Access Compliance Report

Public Rights-of-Way

(Curb Ramps)

Intersection ID: 52784	Main Street: SARDIS_HALL_CT	Cross Street: SARDIS_RD	Location: SW
ADA ID: 5DF380132683	Ramp Type: PerpDiag	Initial Pass/Fail: Fail	Overall Compliance: No
Severity Score: 33.75			
Codes/Mitigation Info/Possible Solution		Field Measurements/Component Compliance

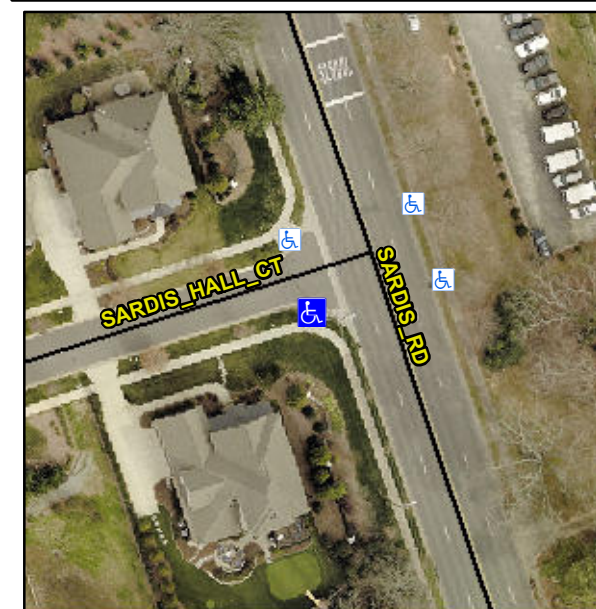
R304.5.1, R304.2.2, R304.5.3

Compliance	Description	Data	Compliance	Description	Data
N/A	Ramp Length (in)	94.5	No	Ramp Slope (%)	8.9
No	Ramp Width (in)	47.0	No	Ramp XSlope (%)	5.8
N/A	Flare Type LT	N/A	N/A	Flare Type RT	N/A
N/A	Flare Slope LT (%)	N/A	N/A	Flare Slope RT (%)	N/A
N/A	Flare Traversable LT?	N/A	N/A	Flare Traversable RT?	N/A
N/A	Landing Length (in)	N/A	N/A	DWS Provided?	N/A
N/A	Landing Width (in)	N/A	N/A	DWS Contrast?	N/A
N/A	Landing Slope (%)	N/A	N/A	DWS Length (in)	N/A
N/A	Landing X Slope (%)	N/A	N/A	DWS Full Width?	N/A
N/A	Landing Curb? (Y/N)	N/A	N/A	DWS Offset (in)	N/A
N/A	Shared Landing?	N/A			
N/A	Gutter Ponding?	N/A	N/A	Gutter Slope (%)	N/A
N/A	Gutter Lip Ht (in)	N/A	N/A	Gutter X Slope (%)	N/A
N/A	Painted X Walk1?	No	N/A	Painted X Walk2?	No
	X Walk 1 Direction	To E		X Walk 2 Direction	To N
N/A	X Walk 1 Width (in)	N/A	N/A	X Walk 2 Width (in)	N/A
	X Walk 1 Slope (%)	7.9		X Walk 2 Slope (%)	1.8
	X Walk 1 X Slope (%)	2.4		X Walk 2 X Slope (%)	5.8

Remove & Replace Curb Ramp With Two New Directional Ramps or Equivalent.
